CITY PLAN COMMISSION**THURSDAY, MARCH 2, 2023****FILE NUMBER:** S223-069**CHIEF PLANNER:** Mohammad H. Bordbar**LOCATION:** Farm to Market Road No. 740, north of Cool Water Circle**DATE FILED:** February 3, 2023**ZONING:** N/A**CITY COUNCIL DISTRICT:** N/A **SIZE OF REQUEST:** 60.36-acres **MAPSCO:** 741C**APPLICANT/OWNER:** Oncor Electric Delivery Company, LLC

REQUEST: An application to create one 60.36-acre lot from a tract of land on property located in the Dallas Extra Territorial Jurisdiction (ETJ) on Farm to Market Road No. 740, north of Cool Water Circle.

PRELIMINARY PLAT OF
ONCER BUFFALO CREEK
LOT 1, BLOCK A
Subdivided in the
Malecay Ferguson Survey, Abstract No. 158
CITY OF DALLAS FILE NUMBER: 5223-069
1 Lot 60.36 Acres

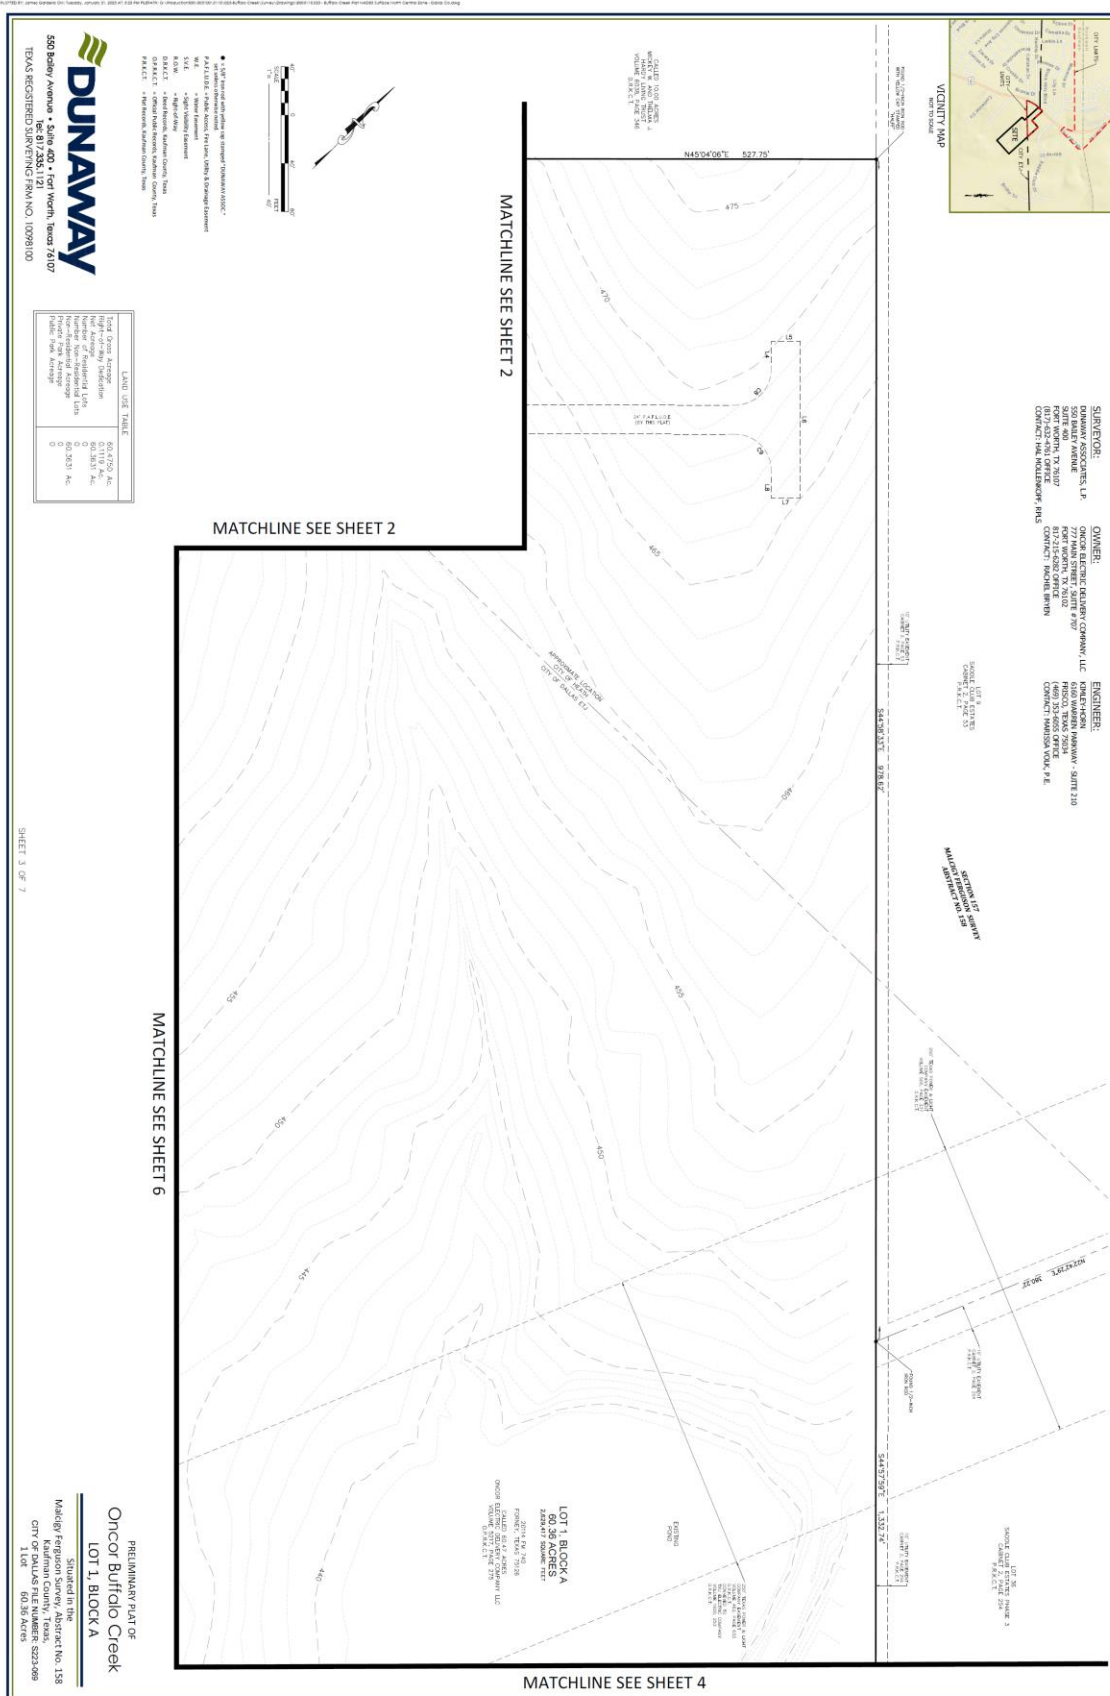
7. On the final plat, include two boundary corners tagged with these coordinates: "Texas State Plane Coordinate System, North Central Zone, North American Datum of 1983 on Grid Coordinate values, No Scale and no Projection."

8. On the final plat, monument all set corners per the Monumentation Ordinance. Prior to submittal of the final plat for the Chairman's signature. The monuments must be verified by the Chief City Surveyors Office in the Public Works Department. *Section 51A-8.617*

17. On the final plat, determine the 100-year water surface elevation across this addition
18. On the final plat, dedicate floodway easement, floodway management area or floodway easement (within common area), with the appropriate easement statement included on the face of the Plat. 51A 8.611(d); DWU Floodplain Management; Drainage Design Manual Addendum V

19. On the final plat, include additional paragraph in Owner's Certificate (pertaining to the floodplain). 51A 8.611(d); DWU Floodplain Management; Drainage Design Manual Addendum V

20. On the final plat, specify minimum fill and minimum finished floor elevations. *Section 51A-8.611(d), Trinity Watershed Management.*
21. On the final plat, show the natural channel set back from the crest of the natural channel. *Section 51A-8.611(d), Trinity Watershed Management.*

22. Prior to submission of the final plat, set floodway monument markers and provide documentation that the monuments have been set. *Section 51A-8.617(d)(1), (2), (3), and (4)*

24. Prior to final plat, submit a completed final plat checklist and all supporting documents.
25. On the final plat, show how all adjoining right-of-way was created. Section 51A-8.403(a)(1)(A)(xxii).
26. On the final plat, all access easement(s) must be recorded by separate instrument(s) and the recording information must be shown on the final plat. Platting Guidelines.
27. Prior to final plat, remove fire lane.
28. On the final plat, add standard owner's dedication language for Dallas ETJ.
29. On the final plat, clarify dedicated easement grantees.
30. On the final plat, annotate all property distances on ad-joiners.
31. On the final plat, increase level of detail on surrounding properties.

32. Additional design information is required for assessment. Site plan must be submitted showing proposed development, building finished floor elevation, development, existing mains – including downstream manhole, and proposed water and wastewater service locations. Submit water/wastewater engineering plans to 320 E. Jefferson Blvd., Room 200, Attention: Water and Wastewater Engineering.

33. Contact the City of Dallas Addressing Manager and Kaufman County 9-1-1 Addressing Coordinator for help determining acceptable name for the new street and verifying that the existing names are correct. Sections 51A-8.403(a)(1)(A)(xii), Section. 51A-8.403. (a) (1) (A) (xiv), Section. 51A-8.506. (e)
